VIRGINIA ELECTRIC AND POWER COMPANY (DOMINION)
NORTH ANNA POWER STATION UNIT 2
RESPONSE TO REQUEST FOR ADDITIONAL INFORMATION
ASME SECTION XI INSERVICE INSPECTION PROGRAM
RELIEF REQUEST N2-I4-LMT-002 – FOURTH INTERVAL
PERIOD 1 LIMITED EXAMINATIONS

**RESPONSE TO REQUEST FOR ADDITIONAL INFORMATION
RELIEF REQUEST N2-I4-LMT-002 REGARDING LIMITED EXAMINATION
COVERAGE**

**VIRGINIA ELECTRIC AND POWER COMPANY (DOMINION)
NORTH ANNA POWER STATION UNIT 2**

*DWG: 12050-WMKS-RC-E-2
Weld #10
0° Limitation Sketch*

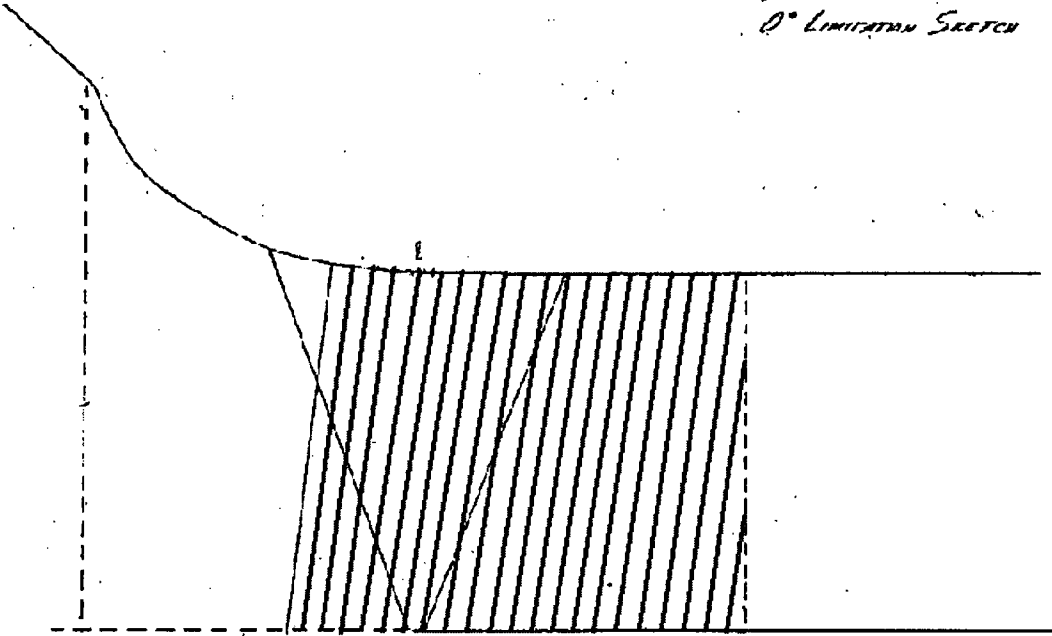
The NRC staff reviewed the examination coverage schematic diagrams the licensee provided on pages 14, 15, and 16 of Enclosure A1-1, and was unable to confirm from the schematic diagrams whether the volume scanned by the ultrasonic testing (UT) included the weld materials and the heat affected zone (HAZ) near the inside diameter (ID) surface of the weld joint. Provide and show clearly on the schematic diagrams on pages 14, 15, and 16 the volume scanned by the UT (e.g., similar to the dashed areas depicted on the schematic diagrams on pages 22 and 23, Enclosure A1-2 to the relief request, that showed the exact volume scanned by the UT).

Below are the sketches for Enclosure A1-1 with the cross-hatching of the volume scanned by UT for Weld #10, as requested.
